**TOWN OF LOS GATOS
PLANNING COMMISSION AGENDA
OCTOBER 09, 2019
110 EAST MAIN STREET
LOS GATOS, CA**

**TOWN OF LOS GATOS
PLANNING COMMISSION AGENDA
OCTOBER 09, 2019
7:00 PM**

SUBJECT: Architecture and Site Application S-18-050. Project Location: **56 Central Avenue**. Property Owner: Andrew and Ashley Bothman. Applicant: Rick Hartman, HOMETEC Architecture. Appellant: Leslie Morley. Project Planner: Jocelyn Shoopman.

#2

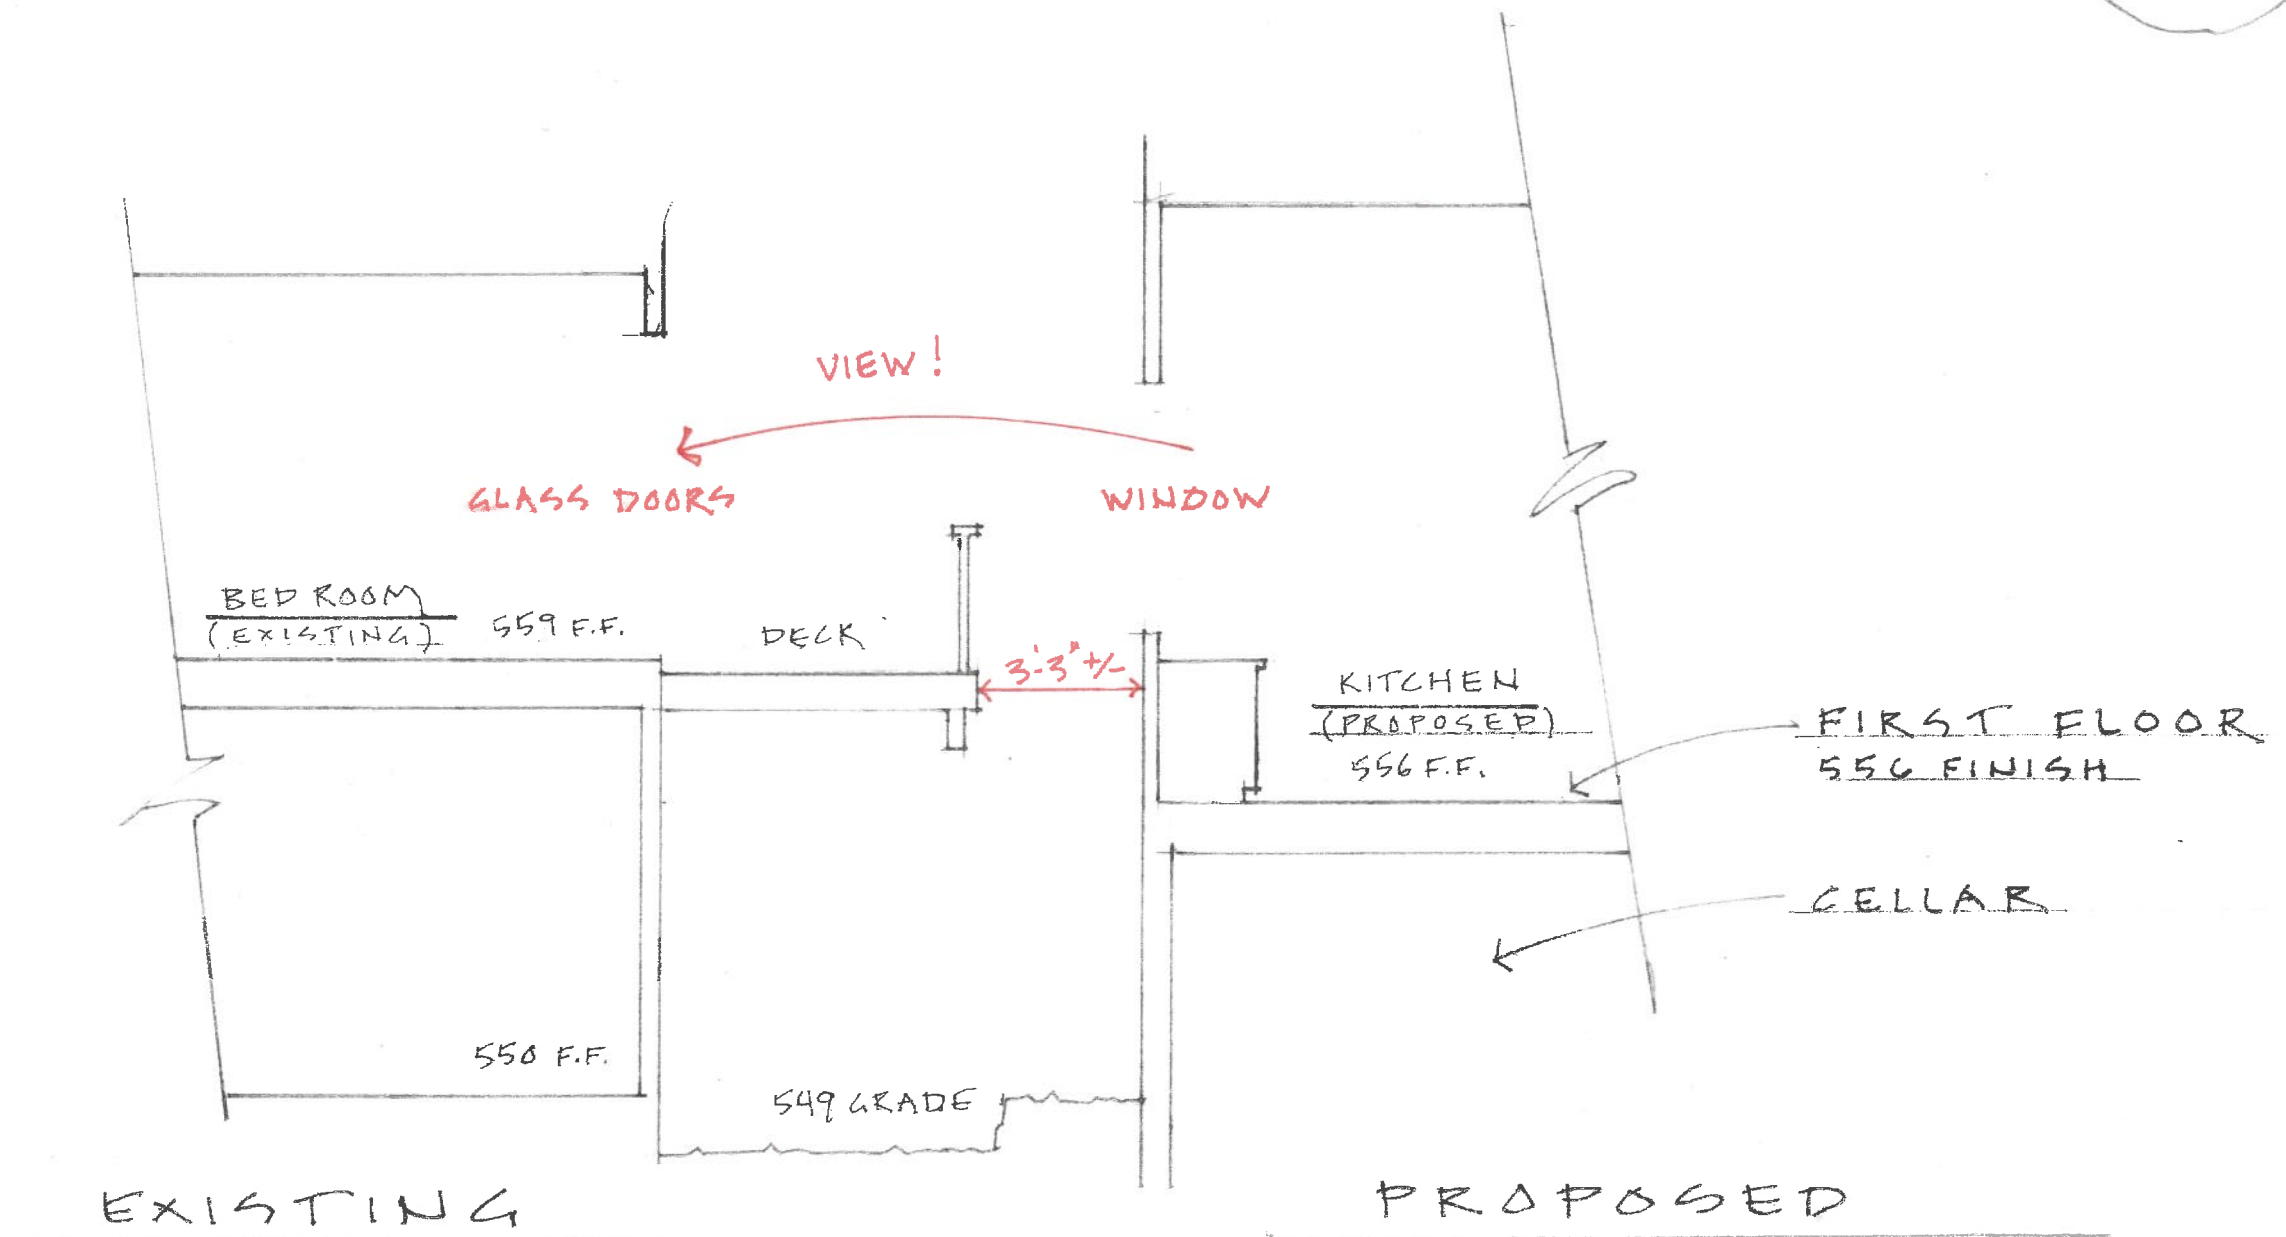
- 1) The 5' setback reduction on both sides. (privacy and noise issues) **(See drawing #1)**
- 2) The large size and design of the home **(See Stewart report for home sizes)**
- 3) The placement of windows **(See drawing #2)**
- 3) The number of mature healthy trees they want to take out

needed to worry about because I have almost 12' of 7' high glass windows and doors off of my master bedroom, privacy. The 2nd floor windows and balcony will be looking down on my master bedroom and balcony. **(See drawing #3)**

STREET SCAPE (ACROSS STREET)
CORRECTED

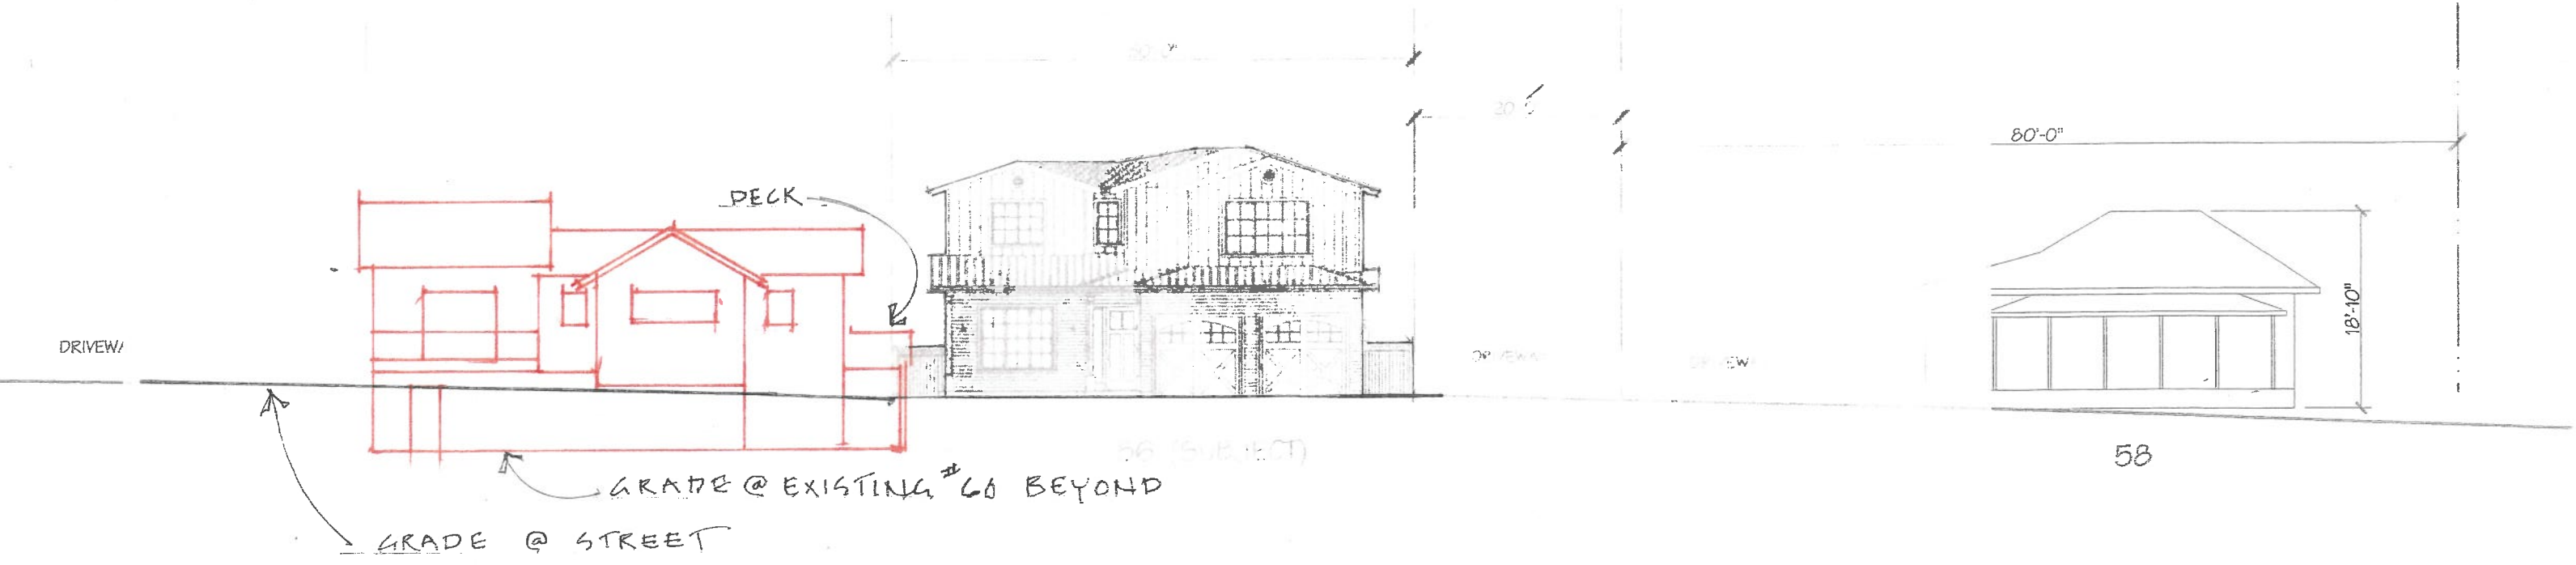
I have walked my neighborhood and there are very few homes with reduced setbacks. The few homes that have reduced setbacks have the reduction on only one side and most of those have used block glass or no windows for mitigation. The 3 50' lots across the street have 10-foot setbacks on both sides. **I do not feel that a reduction in side setbacks for both sides is compatible with the neighborhood or appropriate because my home is so close to the property line. (See drawing #3)**
